**CENTENNIAL PROJECT** *to*  
**WELD COUNTY, COLORADO** ✓  
**Notice of Intent Modification MD-03**  
**File No. P-2008-043** ✓

✓  
**RESPONSE TO DIVISION OF RECLAMATION,**  
**MINING, AND SAFETY**  
**SEPTEMBER 25, 2009, LETTER**

**RE: Request for Additional Information (Notice of Intent (NOI) MD-03, File No. P-2008-043)  
Centennial Project, Weld County, Colorado**

**Centennial Project, Completeness Issues of Notice of Intent Modification MD-03, File No. P-2008-043**

Figure 6-1

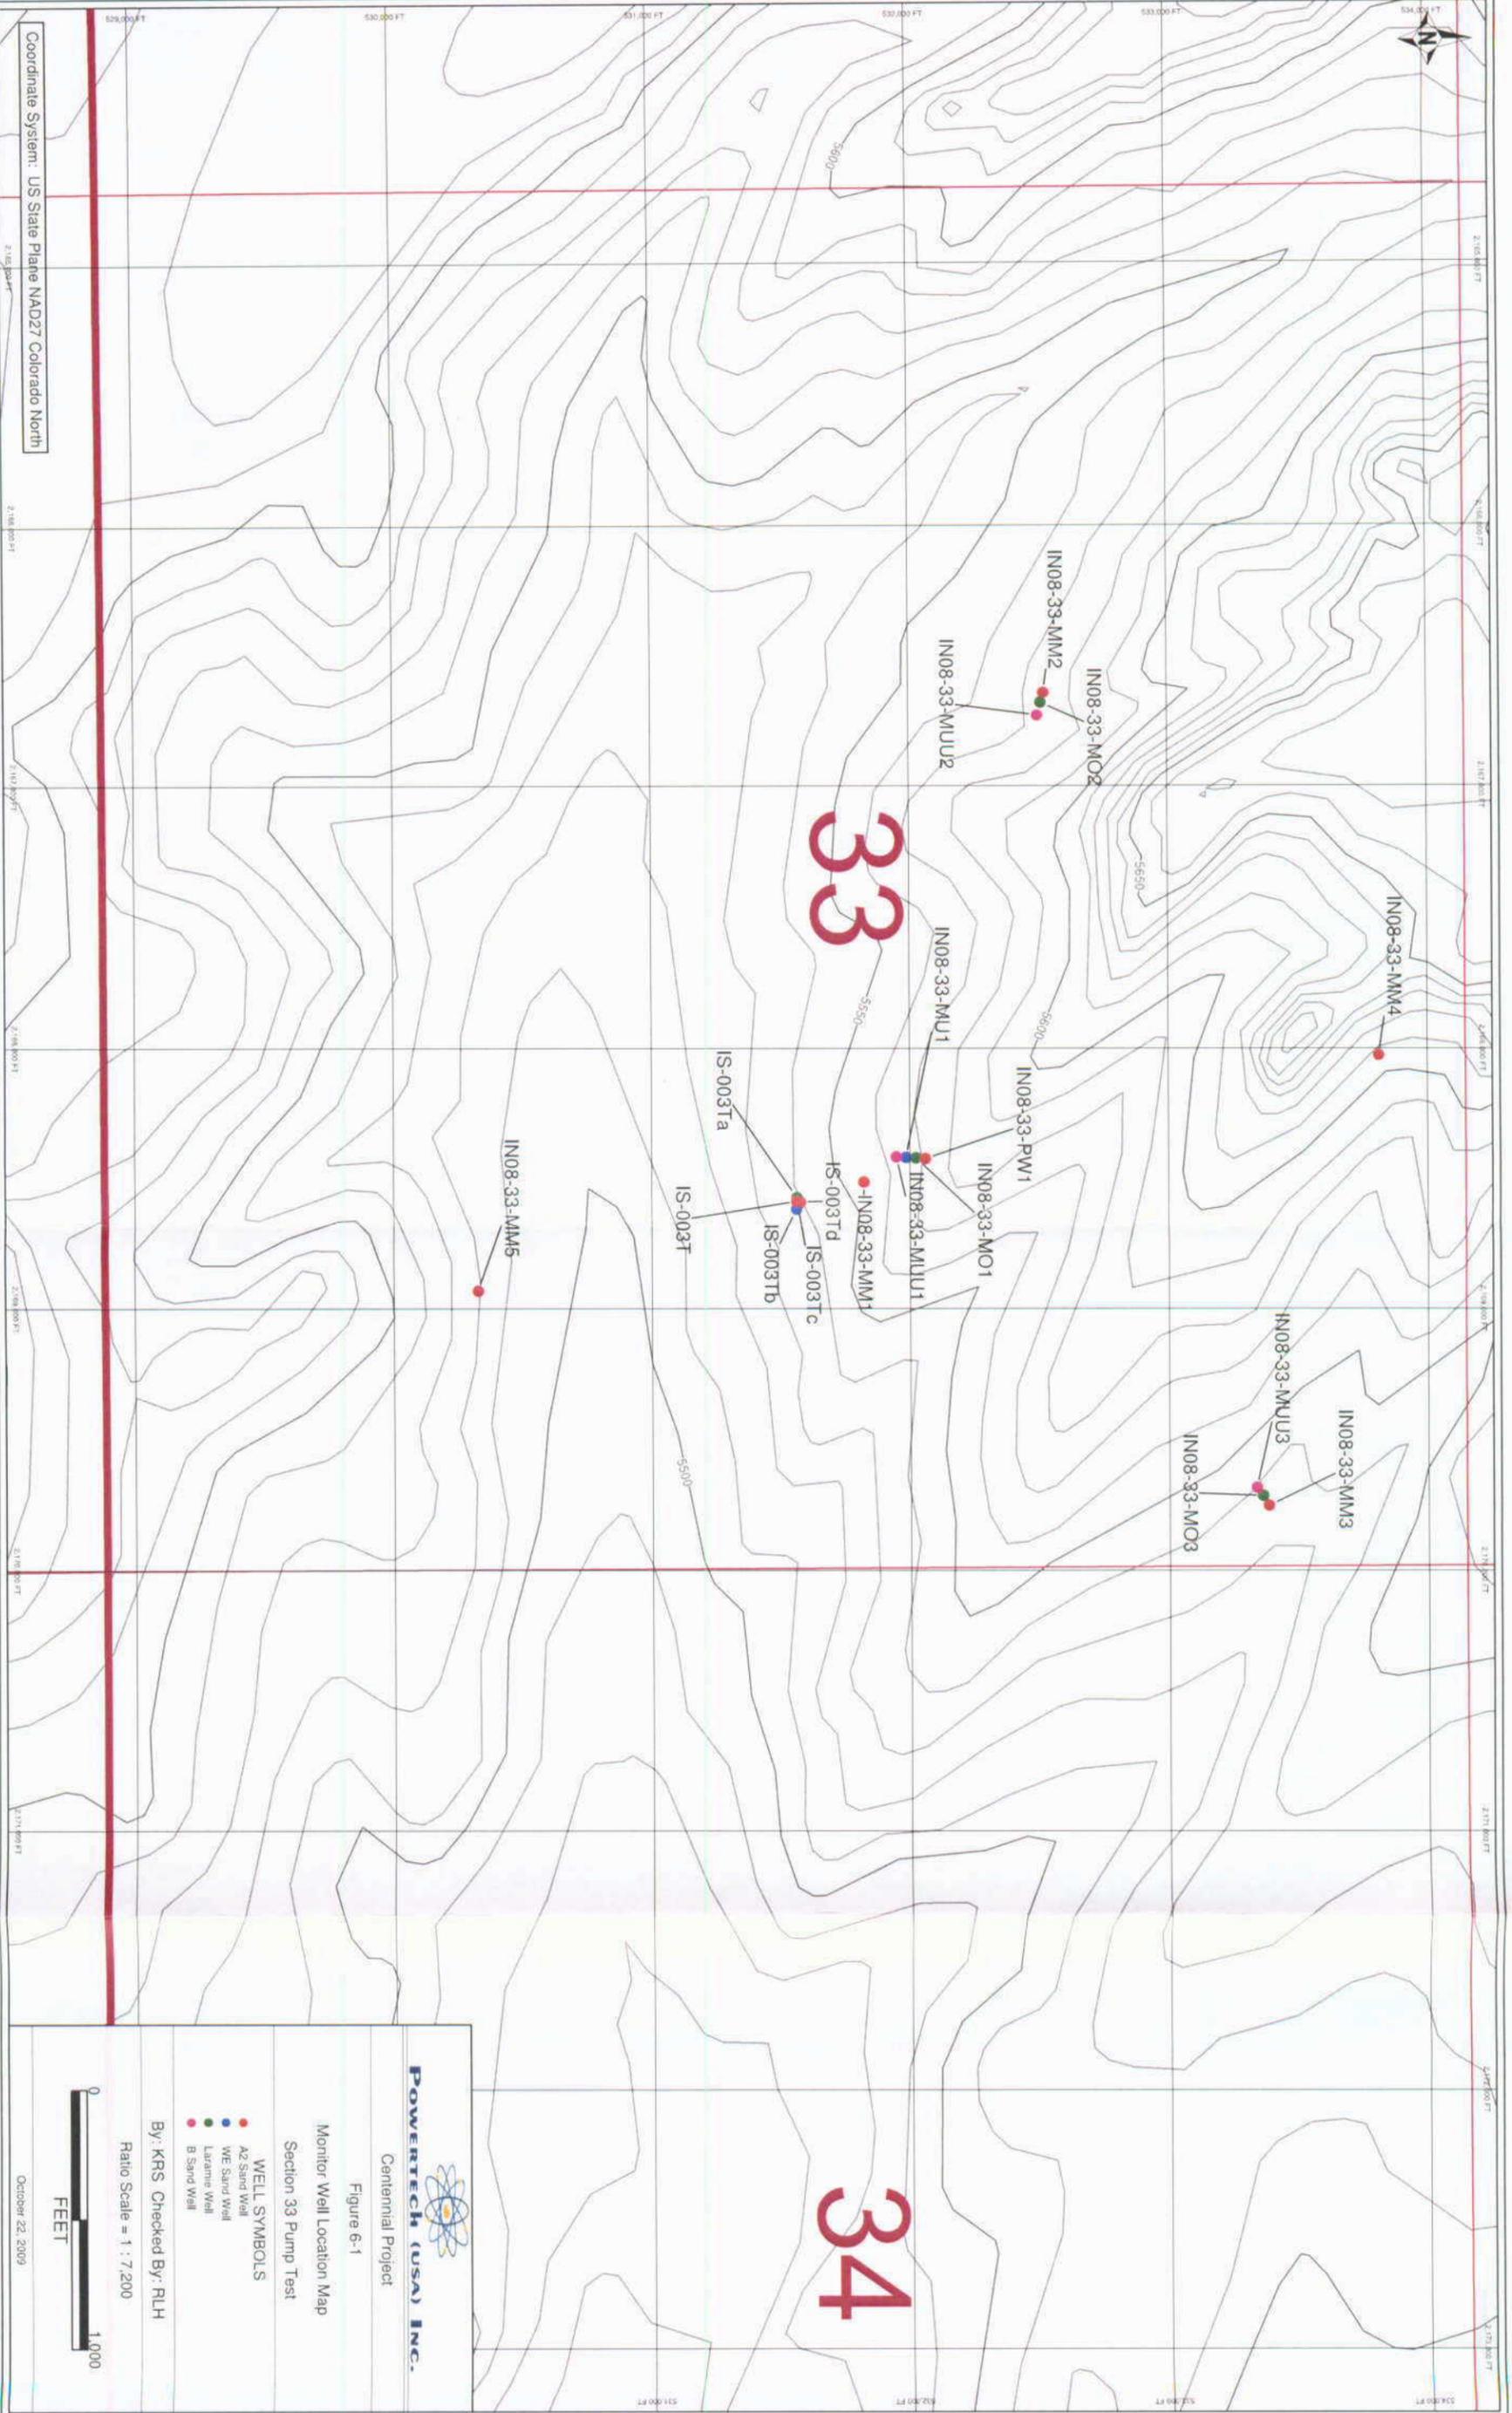
6. *The Section 33 Pumping Test Plan included with MD-03 states on Page 5 that the monitoring wells will be located spatially in order to define the regional potentiometric gradients in the Laramie Formation, A<sub>2</sub> Sand, and B Sand. Initial measurements for this purpose must be collected and the data provided to the DRMS prior to commencement of the proposed pumping test. These initial measurements, which may be single hand tagged measurements, if not already done should be taken as soon as possible, and are in addition to the baseline groundwater level data to be collected over a 72- to 96-hour period prior to initiation of pump testing as described on page 6 of the Pumping Test Plan.*

The locations of the pumping well (IN08-33-PW-1[PW-1]) and monitoring wells for the Section 33 Pumping Test are shown on Figure 6-1. PW-1 is completed within the A<sub>2</sub> Sand horizon, which is the primary mineralized zone. In aggregate, six monitoring wells in Section 33 are also completed within the A<sub>2</sub> Sand, four monitoring wells are completed in the overlying Laramie Formation, two monitoring wells are completed in the underlying WE Sand, and three monitoring wells are completed within the underlying B Sand.

Potentiometric levels measured on September 28, 2009, for the Section 33 Laramie monitoring wells are shown on Figure 6.2. Potentiometric contour maps for the A<sub>2</sub> and B Sands are shown on Figures 6.3, and 6.4, respectively.

**POWERTECH (USA) INC.**  
**Figure 4**  
 Centennial Project  
 Section 33 Pumping Test Layout

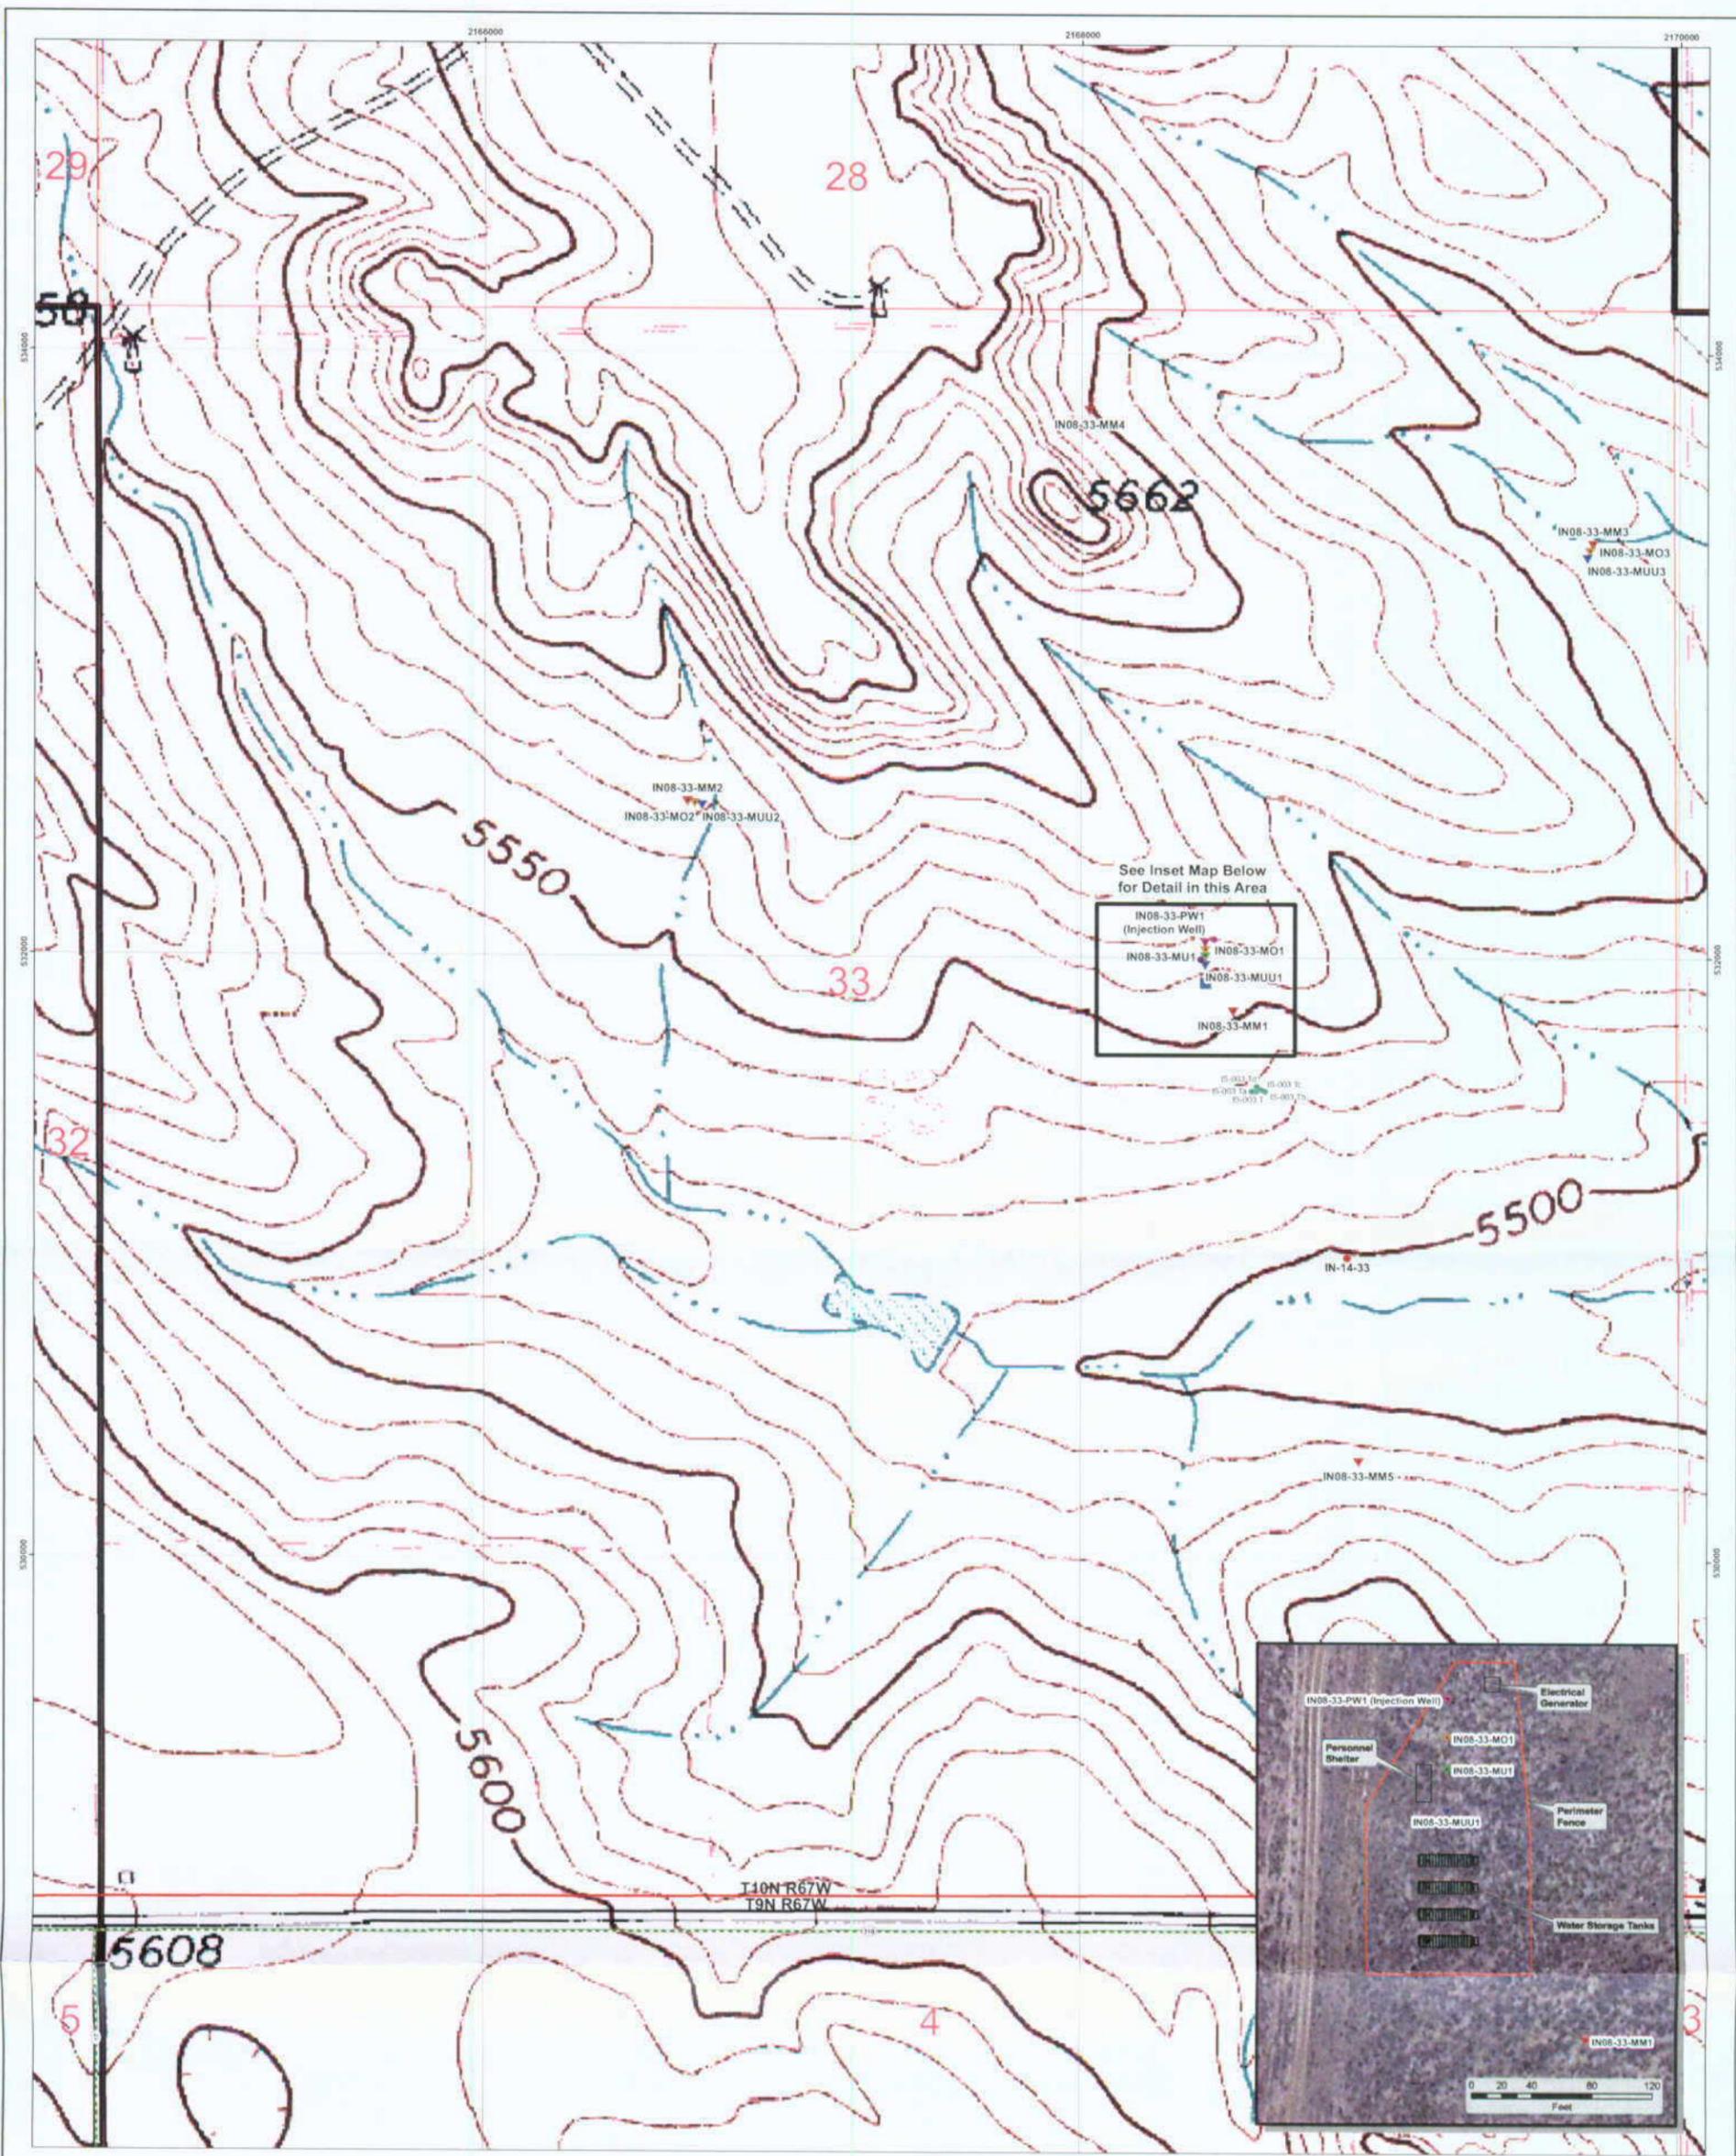
**8. The pumping well and monitoring wells installed for and used in the previous pumping test need to be shown on the Centennial Pump Test Plan map. Since these wells are going to be monitored in the pumping test proposed in MD-03, the information listed in item #7 above must also be provided for these wells.**

Please refer to the Completeness Issue Item #8 Attachment for an updated Centennial Pumping Test Plan Map (Figure 4 of the Centennial Section 33 Pump Test Plan), which includes the locations of all groundwater wells to be monitored at the pump test location. SEO Well Construction and Test Reports for groundwater wells utilized during the previous pumping test have been submitted to the DRMS in the form of the confidential Surety Reduction Request for NOI P-2007-015. Please refer to that report for well completion details. Development reports and drilling/mud logs were not developed and, thus, are not available for these wells. Information used for completing the screened interval of these wells in the target geologic units was derived from exploration boreholes that were advanced immediately adjacent to the previous pumping test groundwater well locations. It should be pointed out that A2 Sand and WE Sand water levels, and differences in hydrostatic head, in the groundwater wells used in the previous pumping test correlate well with water levels in the same geologic units completed in groundwater wells to be utilized in this proposed pumping test. Powertech's position is that this is adequate evidence that the subsurface geology and hydrogeology at the proposed pumping test site is similar to that at the previous pump test site located about 500 feet away, and that groundwater well screens are completed in the target intervals intended at both pump test locations.
